**CITY OF MILWAUKIE
PLANNING COMMISSION
MINUTES
Milwaukie City Hall
10722 SE Main Street
TUESDAY, May 11, 2010
6:30 PM**

5.1 Summary: Riverfront Park
Applicant/Owner: City of Milwaukie
File: DR-09-01, TPR-09-03, WG-09-01, WQR-09-01, and VR-09-03
Staff Person: Ryan Marquardt

Milwaukie Riverfront Park

Fig 1
JOB NO. MAEX00000018

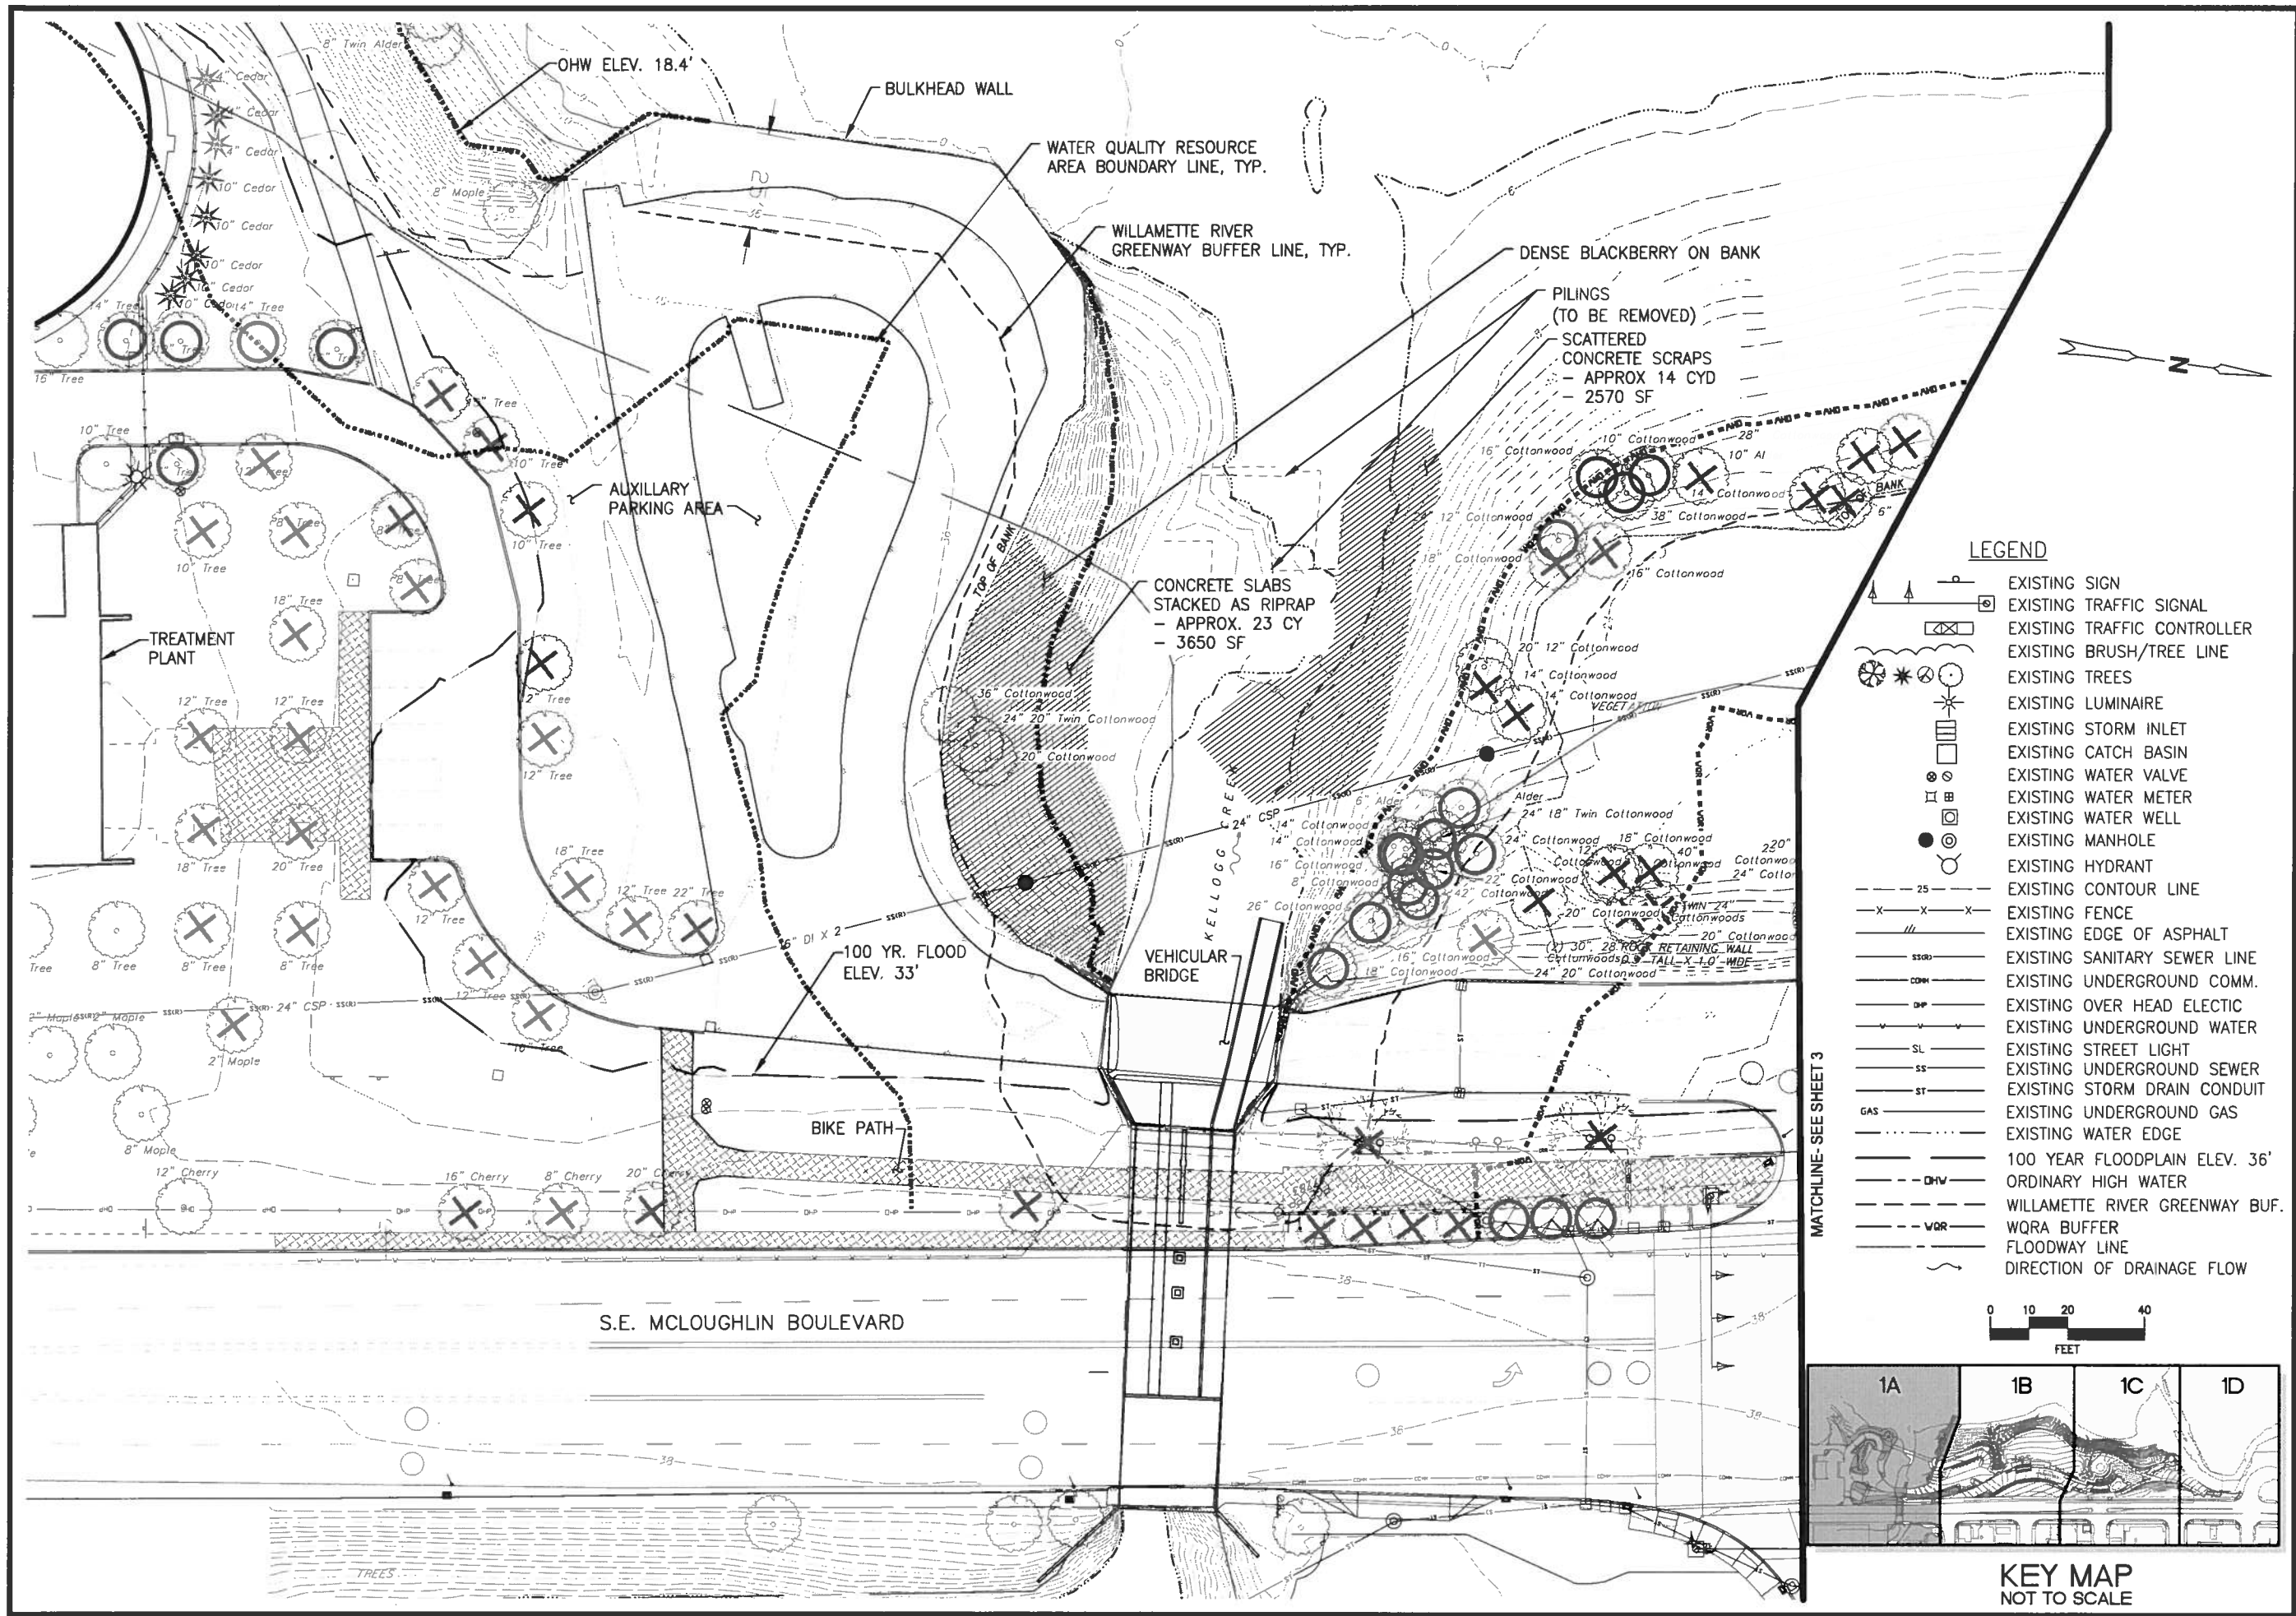
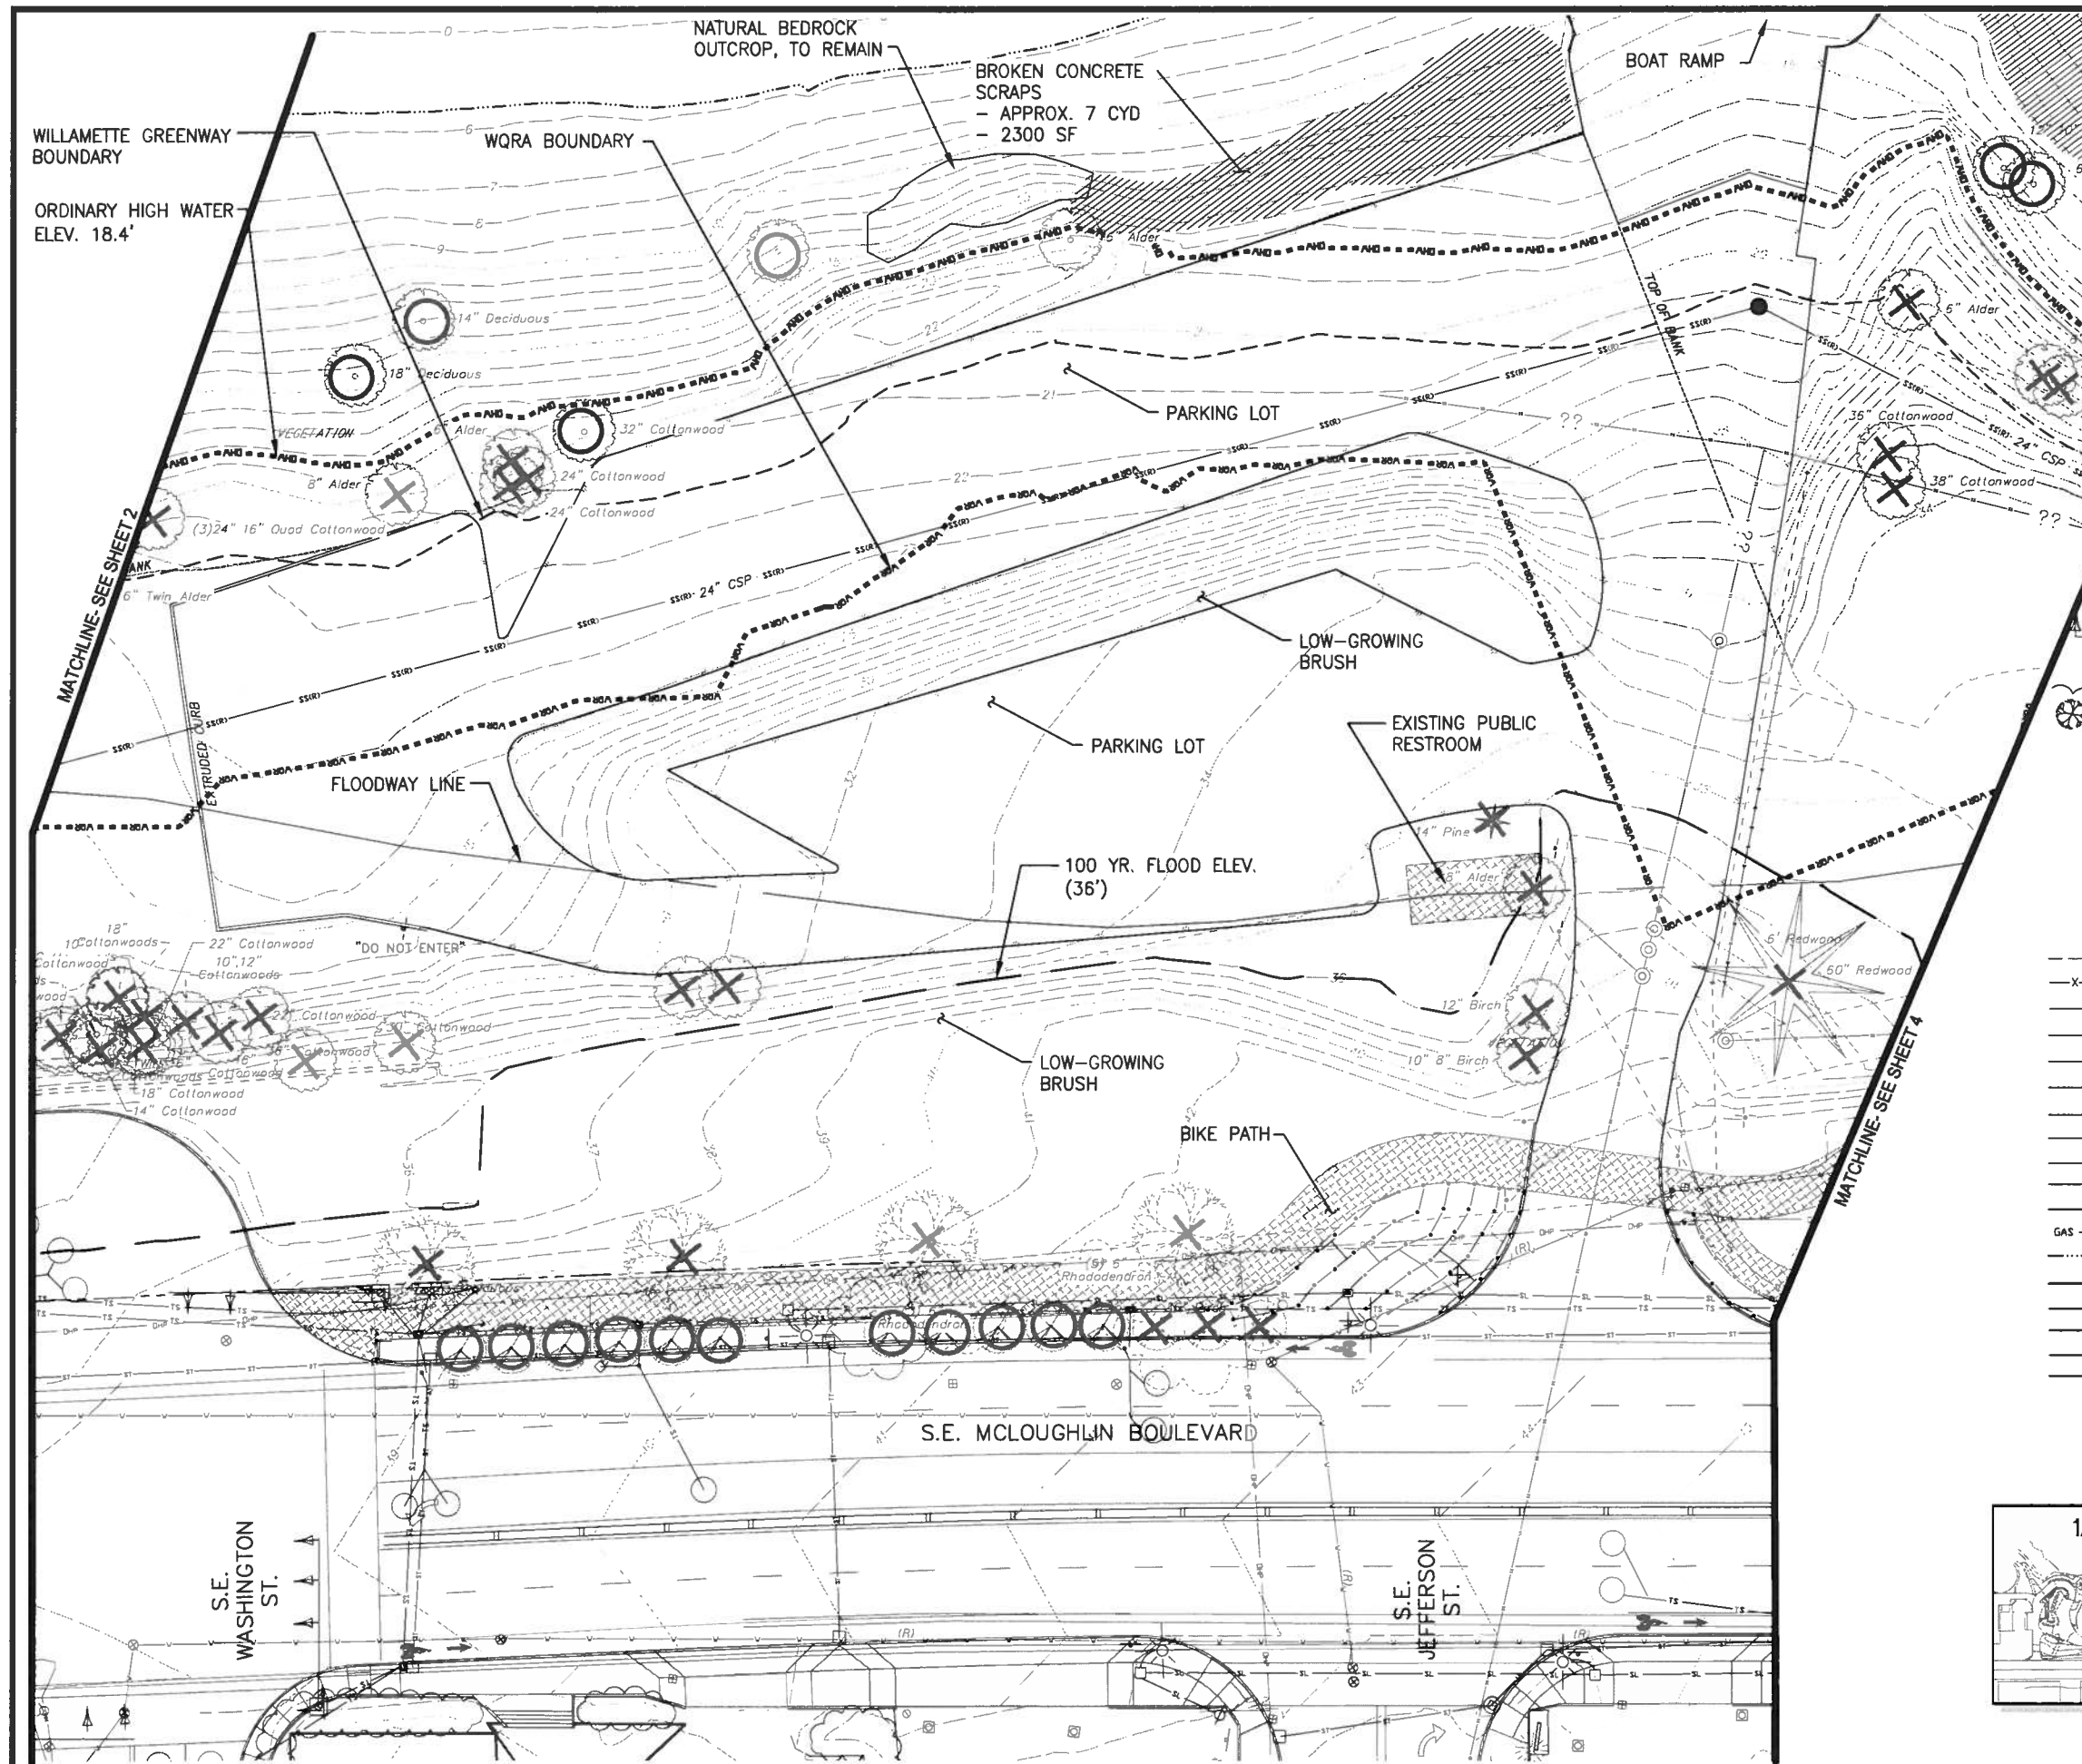
- B. The application is lacking a figure that shows the WQRA boundaries along with all existing natural features. Figure 11 in Tab “B” of the application shows the WQRA boundaries but not all existing natural features. Vegetation communities are only vaguely located on Figure 2 of the 2004 Natural Resource Assessment (NRA; Tab “F”) and WQRA boundaries are only generally sketched in. An overlay of the WQRA boundaries on an aerial photo would be helpful (such as on Figure 2 in the BA, Tab “F”).

- A. Sufficiently addressed in the initial application.
- B. Revised Figures 1, 1A – 1D sufficiently address comments provided regarding this requirement.
- C. Sufficiently addressed in the initial application.
- D. Revised Figures 1, 1A – 1D sufficiently address comments provided regarding this requirement.
